Review of issues raised in submissions - GPS regulatory changes

Utilities Commission of the Northern Territory

28 February 2020

Figure 1 Comparison of NER over-voltage ride through requirements with international practice³

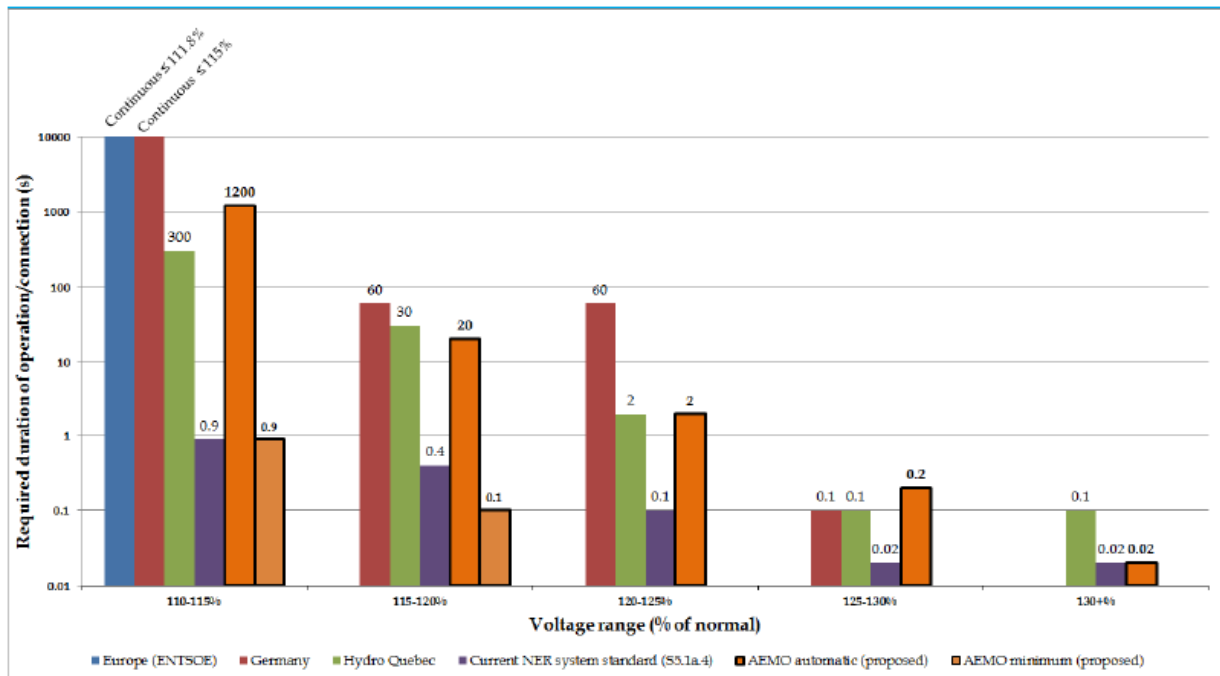
EAL has raised a concern that the voltage ride through requirements specified by the automatic access standard specified in NTC clause 3.3.5.4 may not be able to be met by commonly available inverters.

The AEMC consider this question as part of its 2018 review of generator technical performance standards. The AEMC compared the proposed automatic and minimum over-voltage performance standards with those adopted in a number of jurisdictions around the world with the results plotted in Figure 1.

The AEMC concluded that from its analysis including the results shown in Figure 1 that, “the over-voltage requirements in the proposed automatic access standard were comparable, and in many cases less arduous, than standards in other jurisdictions.”⁴
